3.4 Instrumentation and Control

STD DEP T1 3.4-1 (Figure 3.4a, Figure 3.4b, Figure 3.4c)

Figure 3.4a Safety System Logic and Control (SSLC) ~~Control~~ Interface Diagram

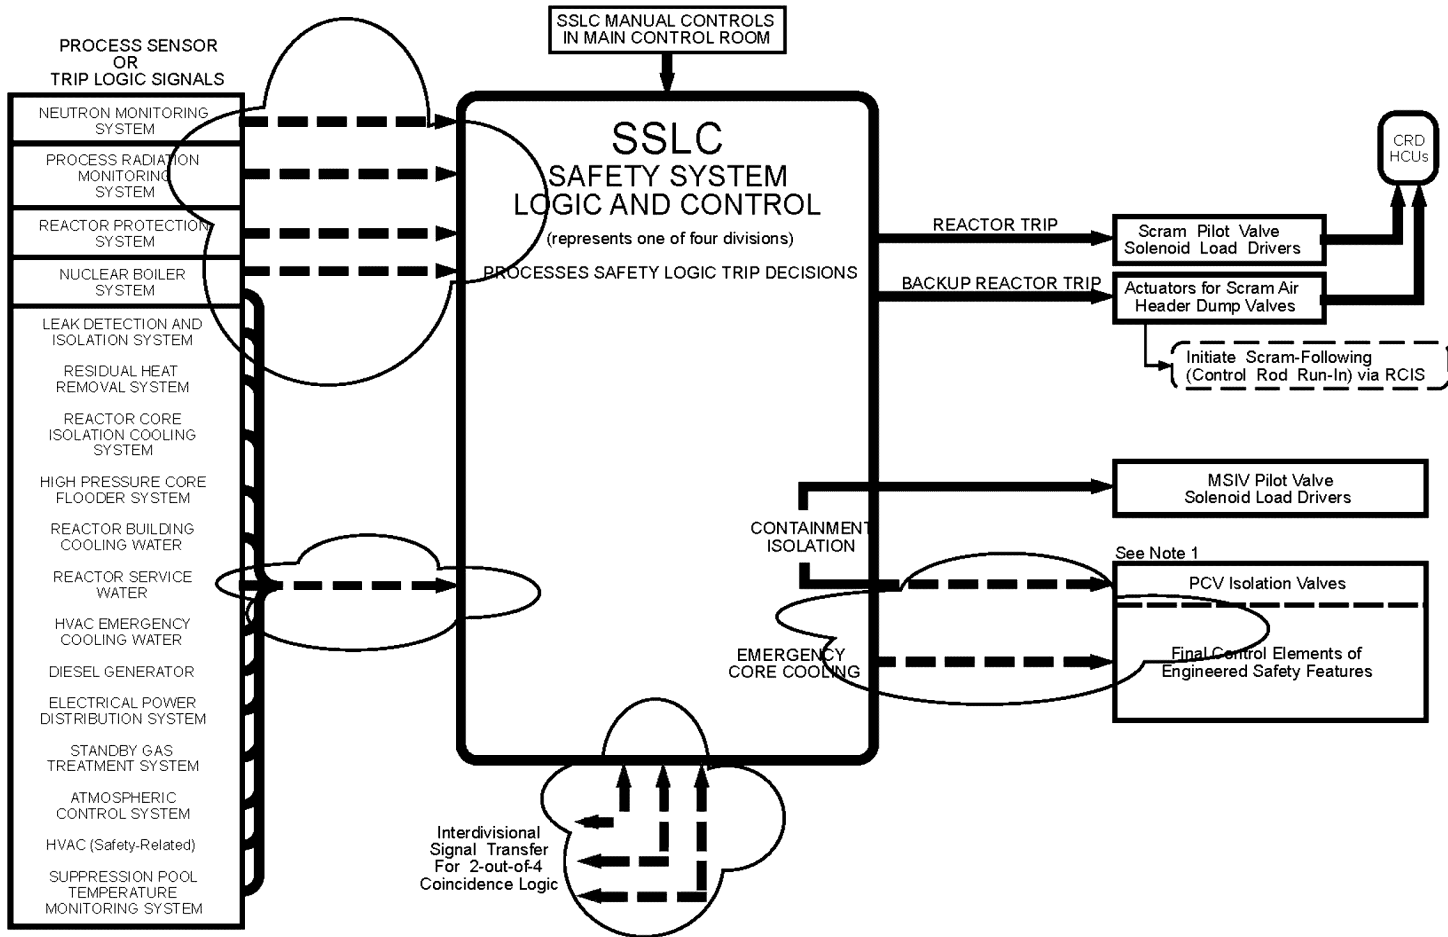
safety-related portions of the Neutron Monitoring System (NMS), the Containment Atmospheric Monitoring System (CAMS) and the radiation monitoring systems. The relationship between SSLC and systems for plant protection is shown in Figure 3.4a.

Figure 3.4b Safety System Logic & Control Block Diagram

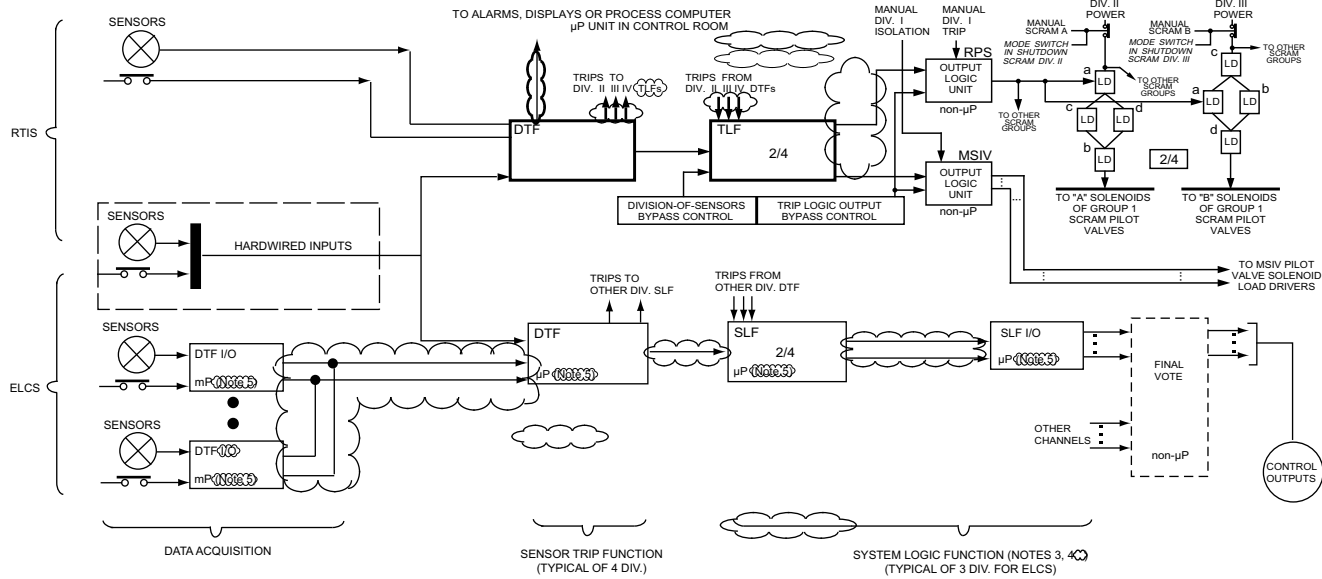
~~The basic hardware functional configuration for one division of SSLC is shown in Figure 3.4b. Each division runs independently (i.e., asynchronously) with respect to the other divisions. The following steps describe the processing sequence and associated function descriptions for incoming sensor signals and outgoing control signals. These steps are performed simultaneously and independently in each of the four divisions:~~

~~As shown in Figure 3.4b, a pair of SLU are located in each of two engineered safety feature (ESF) processing channels, ESF1 and ESF2. ESF1 processes initiation logic for functions which service the reactor vessel at low pressure (e.g. RHR), while ESF2 provides the same support for the vessel at high pressure (e.g. Reactor Core Isolation Cooling (RCIC) System and High Pressure Core Flooder (HPCF) System). Associated LDS and ESF functions are also allocated to these logic channels.~~
